**PREVOST**

**WARRANTY  
BULLETIN**

Wb00-06

<b>DATE :</b> FEBRUARY 2000	<b>SECTION :</b> 07 - Transmission
<b>EXPIRATION:</b> FEBRUARY 2001	
<b>SUBJECT :</b> TRANSMISSION OIL COOLER SUPPORT BRACKET MODIFICATION

**FIGURE 1 : LEFT HAND SIDE OF ENGINE**

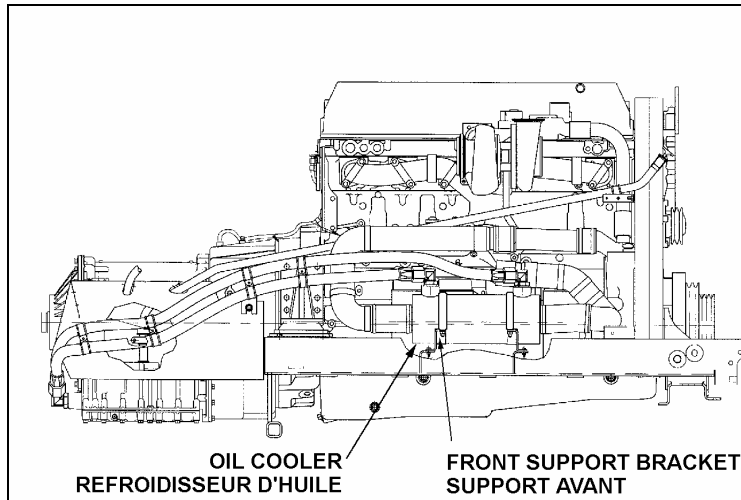
On the above mentioned vehicles, the transmission oil cooler front support bracket is too close to the engine oil filter and there is a risk of perforation due to the rotating movement of the engine. A modification is necessary in order to keep a minimal clearance between the support bracket and the filter.

1. Underneath the vehicle, on the left side of the motor, unscrew the front U-shaped clamp (figure 1).
2. Adequately support the oil cooler.
3. Unscrew and remove the front support bracket (figure 2).
4. Cut the corner of the support bracket to an angle of 45° as per figure 2.
5. Drill two 15/32" (12mm) diameter holes as per figure 2.
6. Using the new holes, reinstall the support bracket.
7. Reinstall the U-shaped clamp. Tighten the bolts properly.
8. The modification is now completed.
